Redline of D1001701-v2
Appert 2019.01.23

CALIFORNIA INSTITUTE OF TECHNOLOGY MASSACHUSETTS INSTITUTE OF TECHNOLOGY		PART NAME	
SYSTEM	SUB-SYSTEM	I/O EXPANSION CHASSIS	
	DAQ	DESIGNER	
		DRAFTER	E.BROWN
		CHECKER	
		APPROVAL	
NEXT ASSY		SIZE	c

SIZE	DWG. NO.	REV.
c	D1001701_v2	
SCALE: 1:1	PROJECTION:	SHEET 1 OF 1

Redline of v2
Appert 2019.01.23

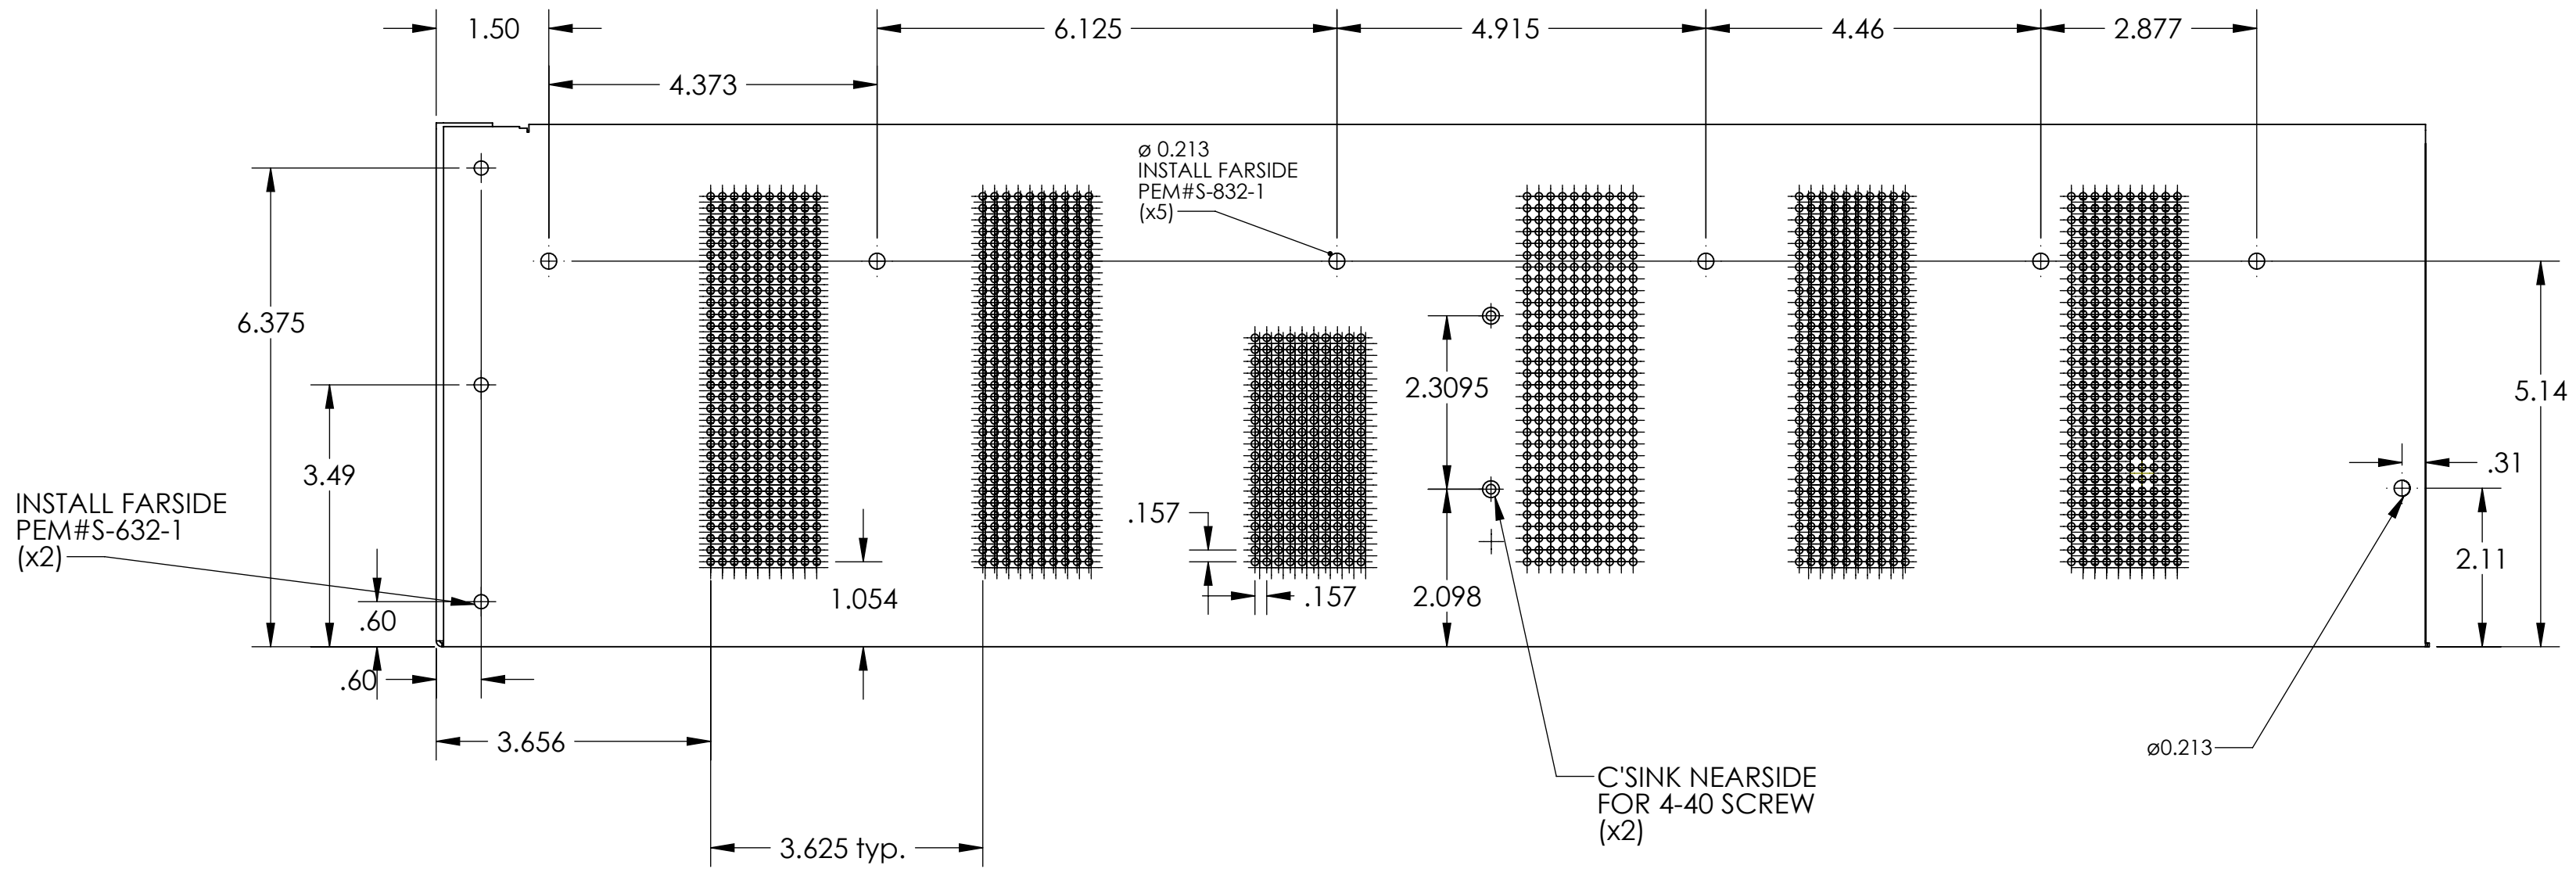
material: 18 gage CRS (.048)

Redline of v2
 Appert 2019.01.23

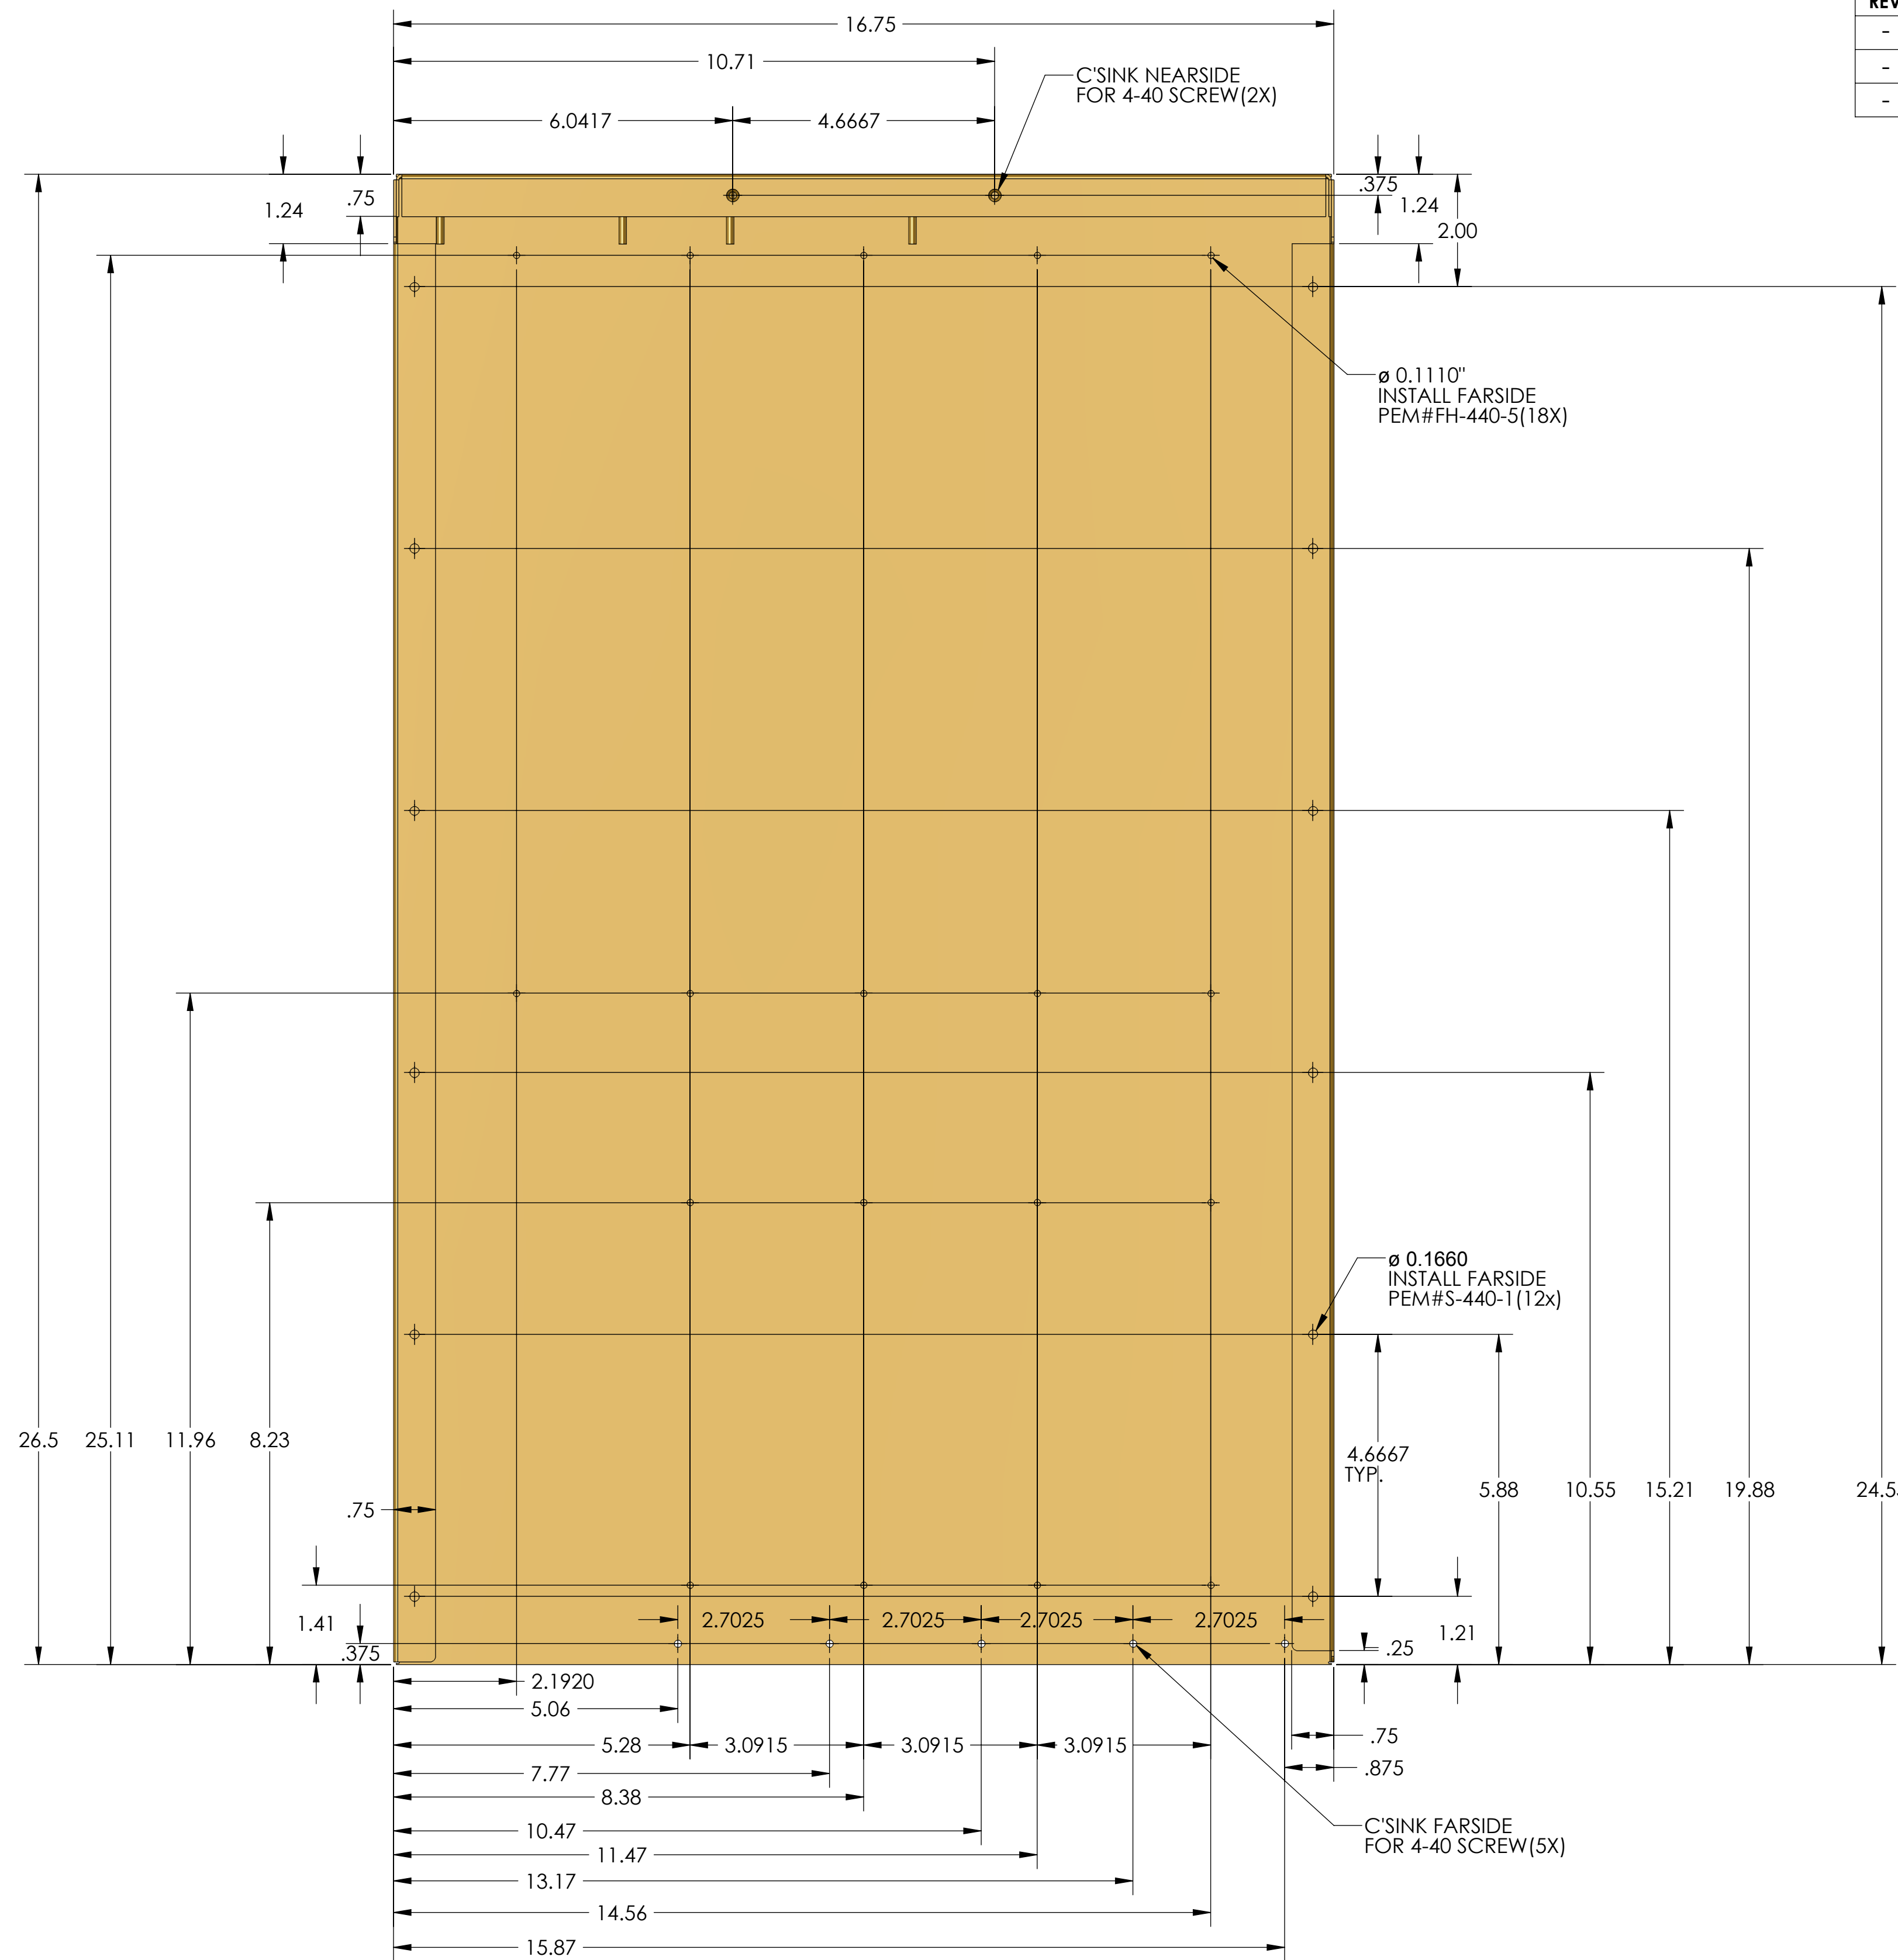
many notes not relevant

material: 18 gage CRS (.048)
